Request for Additional Information: Section 117(3) of the Maritime Area Planning Act 2021

Maritime Usage Licence Application Reference: MUL240047

Source: Drawing No: CK-136-04, Revision: A, Title: Foreshore Licence Map.pfd received

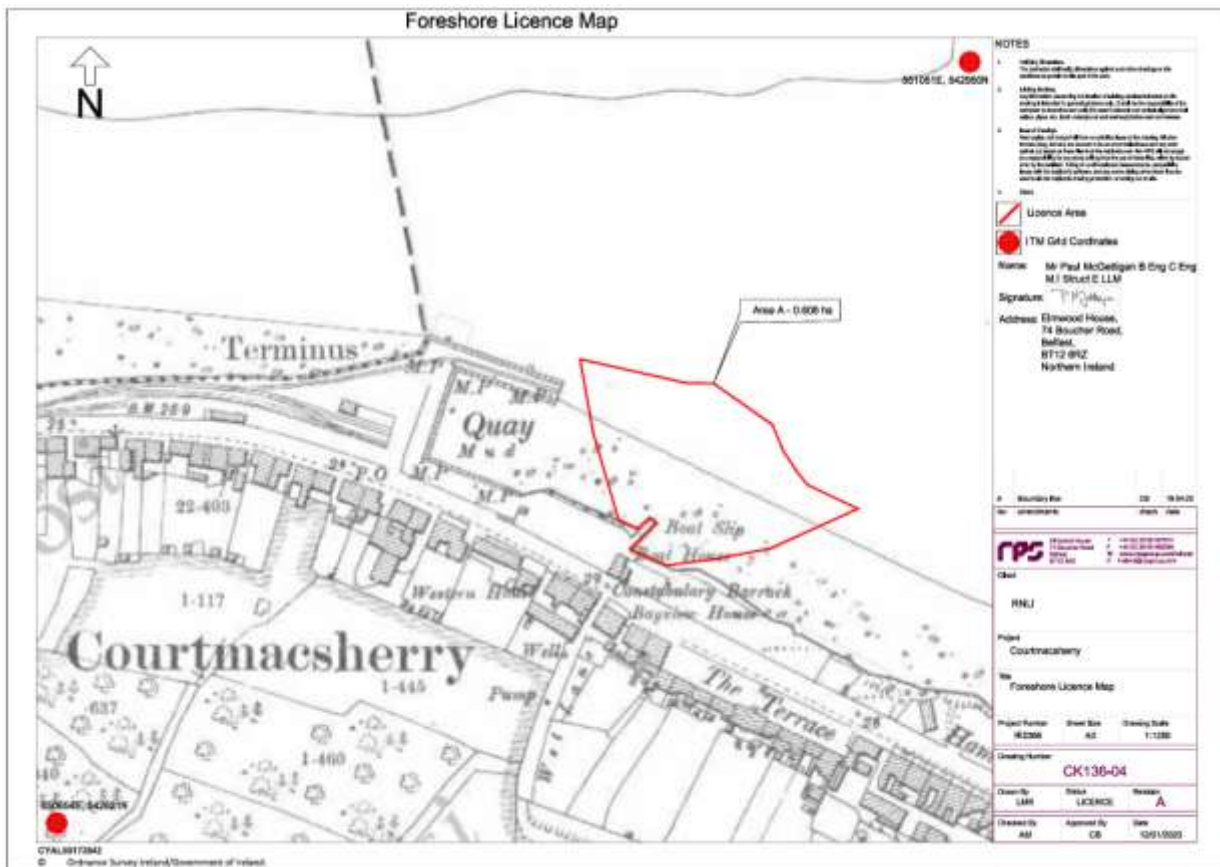
- Would you please request the applicant under Section 117(3) to “confirm that the proposed MUL Area that you seek is intended to align exactly with the High Water Mark by the Chief Boundary Surveyor available for download as High Water Mark - National Water Marks - Ungeneralised – 2026 from <https://arcg.is/1zSran1>. See image below for your current proposed MUL area.”
